Circuit Analysis Report

Test IC	AT86RF231	
Crystal	Holder	NX3225SA
	Frequency	16.000MHz
	Load capacitance	CL=8pF[IEC] (Current) CL=10pF[IEC] (Suggested)
	NDK Spec. No.	STD-CSR-6(J) (*J:CL=10pF[IEC])
Test Circuit	IC	ATRF231 58901-03 1114 PH 0T7966-1
	VDD	+3V / +1.8V
	PCB	TB2-MEGA_231 AVR2067 - Crystal Characterization for AVR RF

2. CIRCUIT DIAGRAM

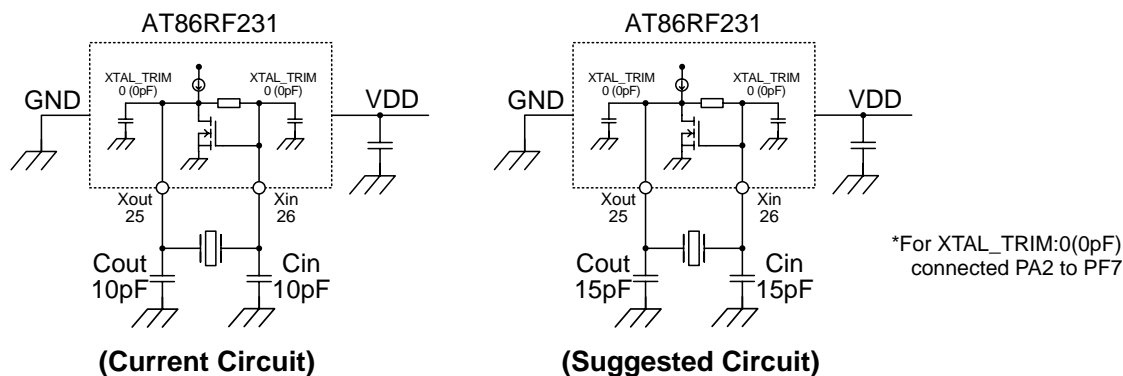
- 1) This crystal unit requires negative resistance of $-R = 800\Omega$ minimum for stable oscillation
- 2) Circuit characteristics

Circuit	Cout/Cin	XTAL_TRIM (Internal Cap)	Frequency deviation dF/F	Negative Resistance -R	Drive Level DL	Startup time Tstr
Current	10pF/10pF	0 (0pF)	+6ppm (CL=8pF[IEC])	3270 Ω	Less than 10uW	1.5ms
Suggested	15pF/15pF	0 (0pF)	-1ppm (CL=10pF[IEC]) Ref.: -26ppm (CL=8pF[IEC])	2040 Ω	Less than 10uW	2ms

- 3) Although the negative resistance of the current circuit is over our target, it seems too large.
- 4) In order to improve negative resistance, we recommend changing external capacitance values from Cout/Cin=10pF/10F to **Cout/Cin=15pF/15pF**. Besides, we recommend changing crystal load capacitance value from CL=8pF to **CL=10pF** in order to improve frequency deviation.
